Our ref: Gregory Place Build-to-Rent (SSD-31179510)

Subject: Response to Submissions

ATTACHMENT 1 – KEY ISSUES

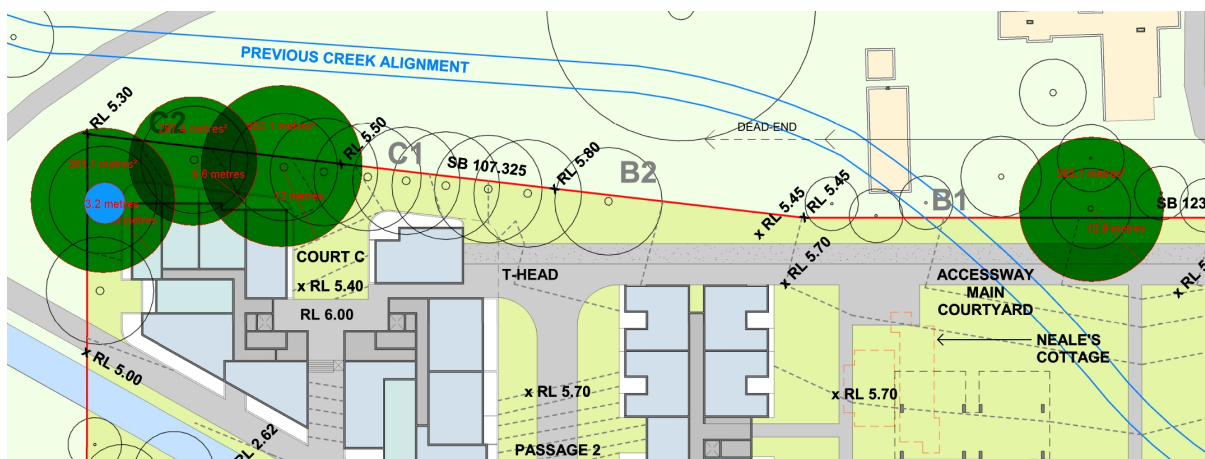
- The Department has identified that trees may not be able to be retained (that are identified to be retained) as they are in close proximity to the building envelopes of Building A and C, the proposed basement, and the internal accessway/emergency driveway. The submitted architectural plans indicate that some trees to be retained would have incursions into their tree protection zones (TPZ) of more than 10% (a major encroachment under *AS 4970-2009 Protection of trees on development sites*). Their canopies would also require significant trimming, and some trees may have incursions into the structural root zones (SRZ). The European heritage report, community consultation report, wind report, and view analysis all emphasise the importance of these trees being retained.

Note: Above calculations are based upon tree diameter data from the survey plan. They indicate more than a 25% (major) incursion into the TPZ of trees to be retained on the subject and adjacent sites (green colour). A SRZ encroachment (blue) is identified for tree No. 192 (as per survey plan). The basement plan indicates that the setbacks to the trees would be less than the ground floor plan which further increases the incursion.

- The following must be submitted with regard to tree preservation:
 - o A tree survey plan that clearly shows tree numbers and their location.
 - o A site plan that shows the TPZs and SRZs of trees to be retained in relation to proposed building envelopes.
 - o TPZs of trees to be retained must not have more than a 10% incursion into their TPZs and no incursions into their SRZs. This may require reduced building envelopes.
 - o A discussion on the amount (percentage) of tree pruning required for retained trees before construction.

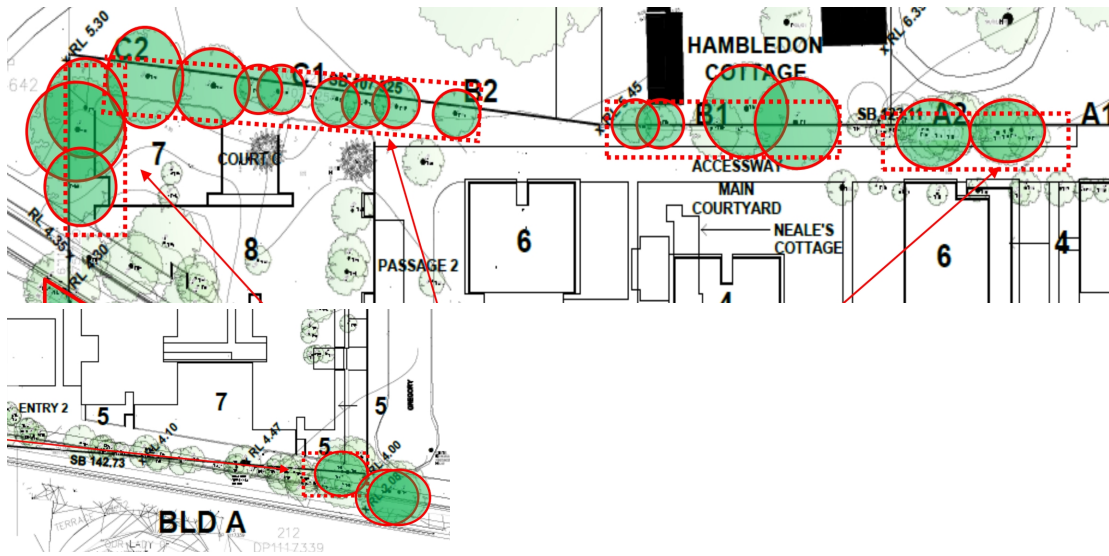
- The arboricultural assessment report does not clearly identify tree numbers and contains several technical issues including:
 - the provision of tree protection fencing within building envelopes.
 - no discussion about required tree canopy pruning.
 - no discussion about the individual level of impact trees would occur. E.g., TPZ, SRZ incursions.

Note: The AIA shows tree protection fencing within building envelopes and trees to be retained within close proximity to building envelopes. Tree numbers are not visible.

- o An amended tree protection plan that shows tree protection fencing outside of proposed building envelopes.

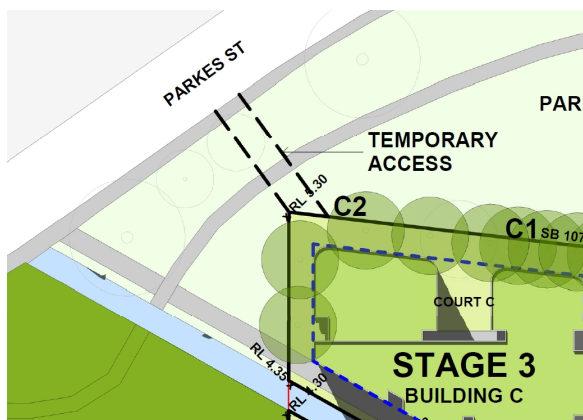
The architectural plans indicate that temporary access to the north-west portion of the site would be provided via Parkes Street. This location on the site is proposed to have tree protection fencing. In addition, the general storage of materials is recommended outside of a retained TPZ.

Note: The architectural staging plan shows temporary access to the site via Parkes Street that would be within the proposed tree protection fencing.

- Clarification if temporary construction access from Parkes Street is sought as part of this application. If so, confirm that land owner's consent has been provided, and include a discussion on tree impacts within the amended Arboricultural Impact Assessment.
